Cut & Bend Rebar – JOB ADVICE

BBS No 钢筋加工表	<u>MVR-TT-H318</u>	Total Weight 总重量	<u>4, 151</u>
Contract 合同号码		Total Pages Attached 统计页数	1+6
Customer 承包商	<u>WOH HUP PTE LTD</u>	Gate:	
Project Title 施工地址	<u>MARINA VIEWLP 28F 1 STRAITS BIVD,SINGAPORE 018906</u>		
Description 形容	L37层 CJ4-2 墙 《149.920~153.245》		
Date Order 订单日期	24-Aug-2026	Date Required 交货日期	31-Aug-2026
Remarks 评论			
Check/Approved By 检查/审核/订货人	<u>Zhou Bing</u>	Handphone 手提电话	<u>9847 1699</u>
Site Contact Person 联络人	<u>Kumar</u>	Handphone 手提电话	<u>8133 8587</u>
Material Receiver 收货人	<u>SIVA</u>	Handphone 手提电话	<u>8426 2921</u>
Site Telephone 工地电话		Site Fax No 传真号码	
Scheduler 开料人	<u>Lu Yong Bing</u>	Handphone 手提电话	<u>8982 7022</u>
<u>***Please Allow 5 days for ??? To Process Your Order***</u>			
<u>51 Tuas South Street 5,Singapoer637644</u>

MVR PJW CO WH CST ZZ ZZ SK W 2659A Typical Resi Wall Recess Trimmer Bar Optimisation VE Rev A

TECHNICAL
WOH HUP (PRIVATE) LIMITED
MARINA VIEW RESIDENCES (MVR)

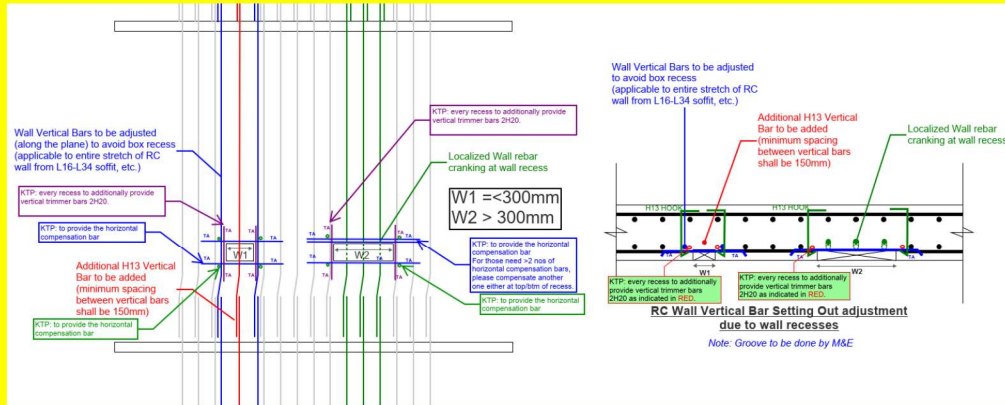
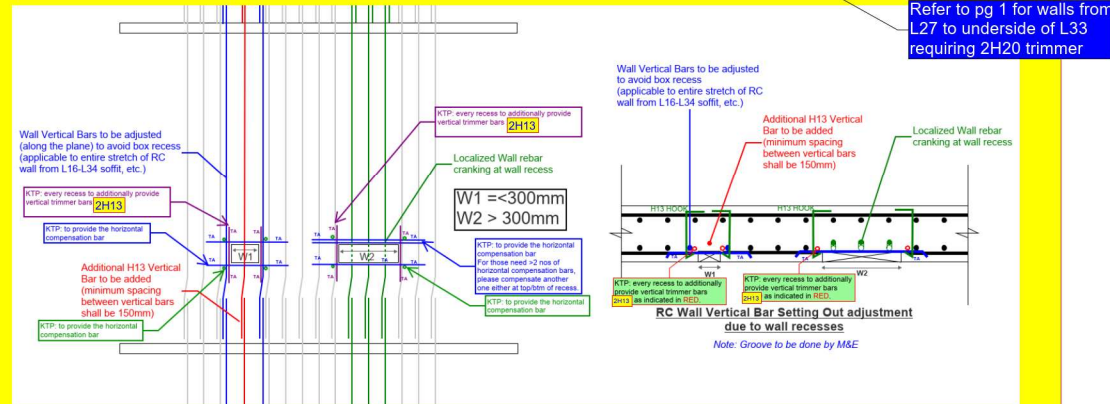
THE REST OF WALLS FROM L27- **UNDERSIDE OF L33, L36 to ROOF** are allowed to reduce the vertical trimmer bars to be **2H13** only.

KTP 20260324:

FOR L33 TO UNDERSIDE L36, kindly provide the trimmer bar as per previous approved sketch, which is 2H20 or equivalent.

*2H20 trimmer bars or equivalent size.

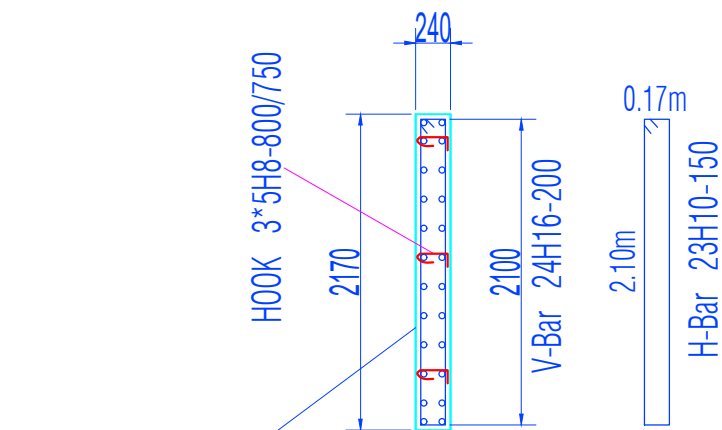
注意：底部150mm高有Recess
Recess位置水平铁向上绑

55 C1-2
1 : 25

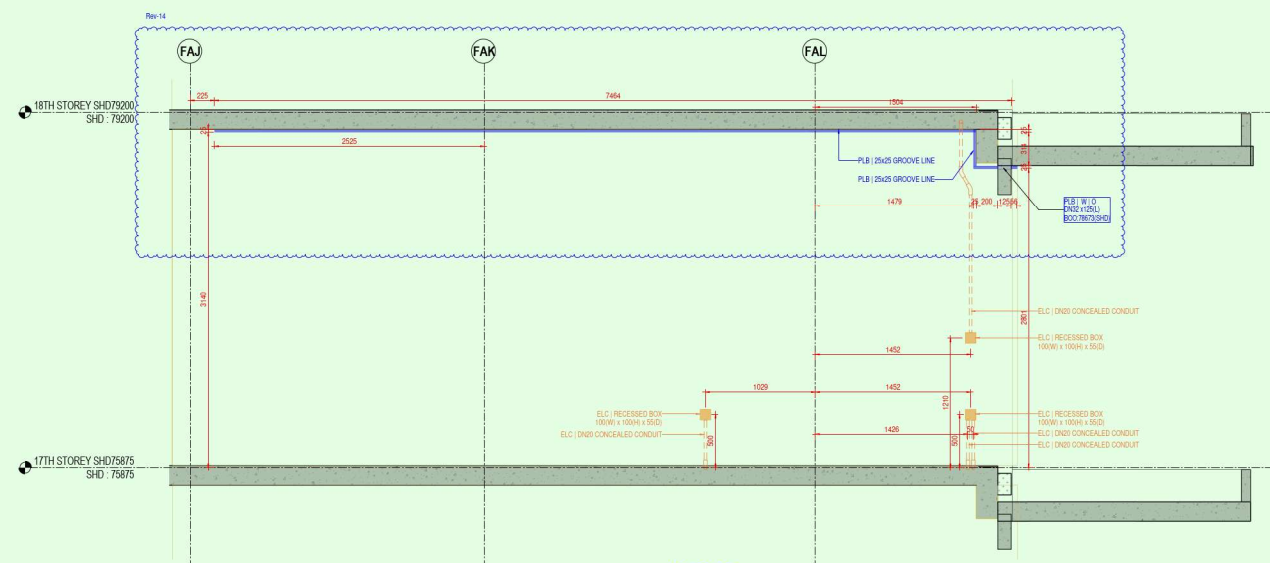
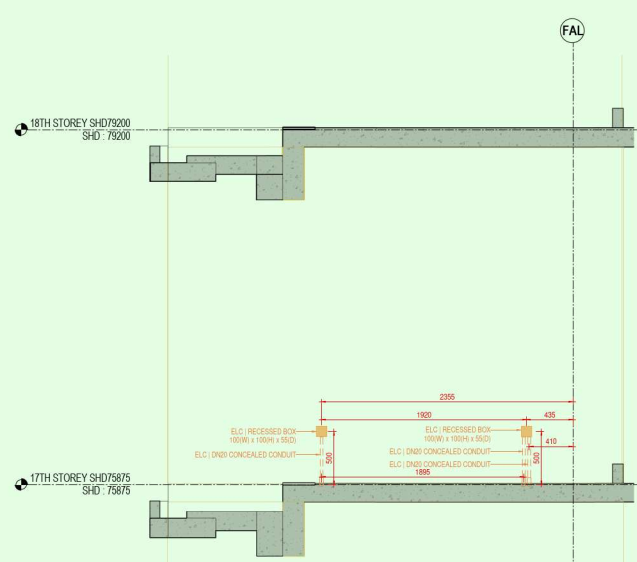
KTP: No objection, all penetrations/recesses please follow previous approved details
